Access Compliance Report Public Rights-of-Way (Curb Ramps)

Main Street: HEATHCLIFF_DR Cross Street: FOOTHILL_BLVD Location: W

ADA ID: RPRK211012123256 Ramp Type: Type 4 - Parallel Initial Pass/Fail: Fail Overall Compliance: No Severity Score: 16

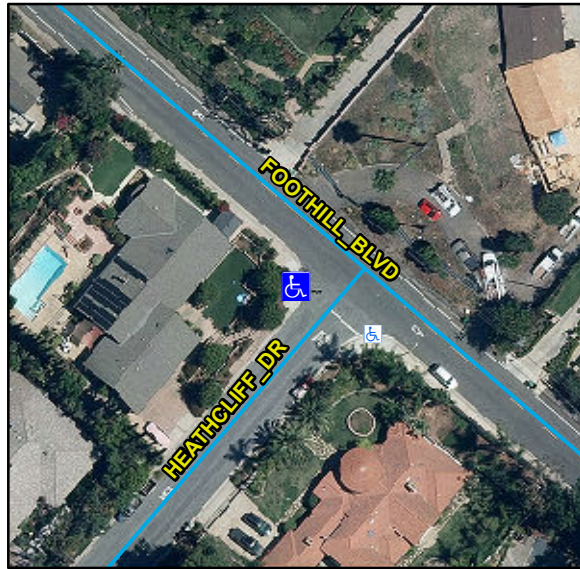
Compliance	Description	Data	Compliance	Description	Data
N/A	Ramp Length LT (in)	134	N/A	Ramp Length RT (in)	90
Yes	Ramp Width LT (in)	74	Yes	Ramp Width RT (in)	84
No	Ramp Run Slope LT (%)	11.8	Yes	Ramp Run Slope RT (%)	0.5
Yes	Ramp Cross Slope LT (%)	0.4	No	Ramp Cross Slope RT (%)	3.4
N/A	Landing Present	N/A	N/A	DWS Provided	N/A
N/A	Landing Length (in)	N/A	N/A	DWS Contrast	N/A
N/A	Landing Width (in)	N/A	N/A	DWS Length (in)	N/A
N/A	Landing Run Slope (%)	N/A	N/A	DWS Full Width	N/A
N/A	Landing Cross Slope (%)	N/A		DWS Offset Type	N/A
N/A	Landing Movement Obstructed?	N/A	N/A	DWS Offset Left (in)	N/A
	Landing Movement Type	N/A	N/A	DWS Offset Right (in)	N/A
N/A	Landing Shared	N/A			
N/A	Clear Space	Yes			
N/A	Clear Space To Crosswalk (in)	N/A			
N/A	Marked Crosswalk 1	No	N/A	Marked Crosswalk 2	No
	Crossing 1 Direction	SE		Crossing 2 Direction	NE
N/A	Marked Crosswalk 1 Width (in)	N/A		Marked Crosswalk 2 Width (in)	N/A

N/A	Ramp Inside Crosswalk 1	N/A	N/A	Ramp Inside Crosswalk 2	N/A
	Crossing 1 Slope (%)	11.2		Crossing 2 Slope (%)	6.7
	Crossing 1 Cross Slope (%)	4.7		Crossing 2 Cross Slope (%)	7.8
N/A	Gutter Ponding	N/A	N/A	Curb Slope	0.7
Yes	Gutter Lip Height (in)	0		Road Run Slope (%)	8.4
N/A	Gutter Run Slope (%)	N/A		Road Cross Slope (%)	9.9
N/A	Gutter Cross Slope (%)	N/A	Yes	Perpendicular Joint Present	Yes
Yes	Overall Surface Condition	Acceptable			
	Cross Gutter Present?	No		Spandrel Present?	No
	Replace Cross Gutter?	N/A		Replace Spandrel?	N/A

Remove & Replace Curb Ramp With Two New Directional Ramps or Equivalent.
